IEEE 802.11
802 LAN Access Method for Wireless Physical Medium

DATE: March 1, 1994

TITLE: EVALUATION OF THE DFWMAC

Figure 1 Suggested alternate diagram for the DFW Protocol Stack shown in Figure 3-5 of P802.11-93/190.

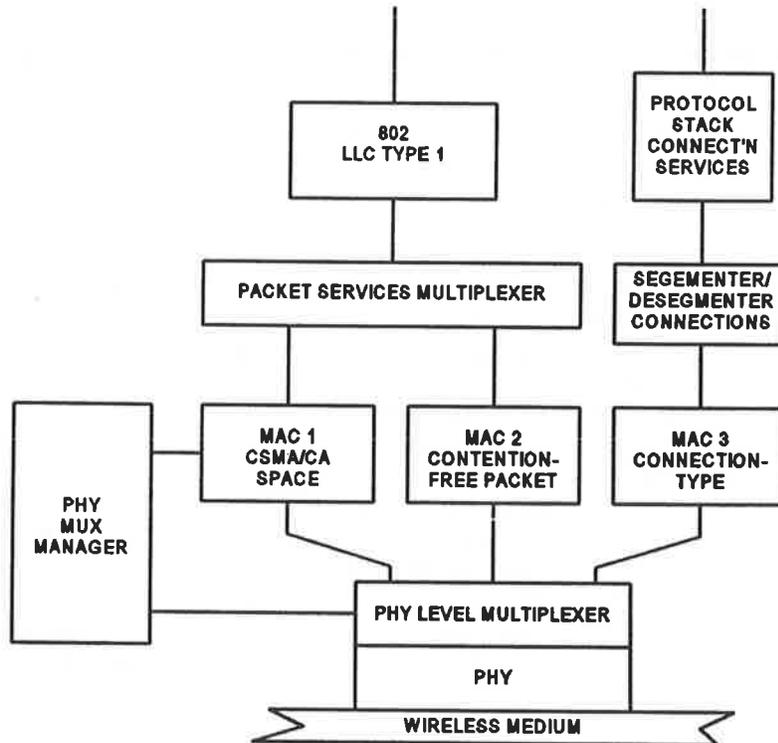
The apparent model for the DFWMAC is shown below. It should be noticed that there is a recursive aspect where the information decoded in the received messages may change the dimensions of the frame structure.

The different MACs must interact with each other. A fundamental problem is the interlocking of allocation events between the multiple services. Use of the acronym "time-bounded" provides the benefit of avoiding responsibility for limitations on setup and transfer delay and on lost segments that might be imposed if compatibility with well known telecom standards were necessary.
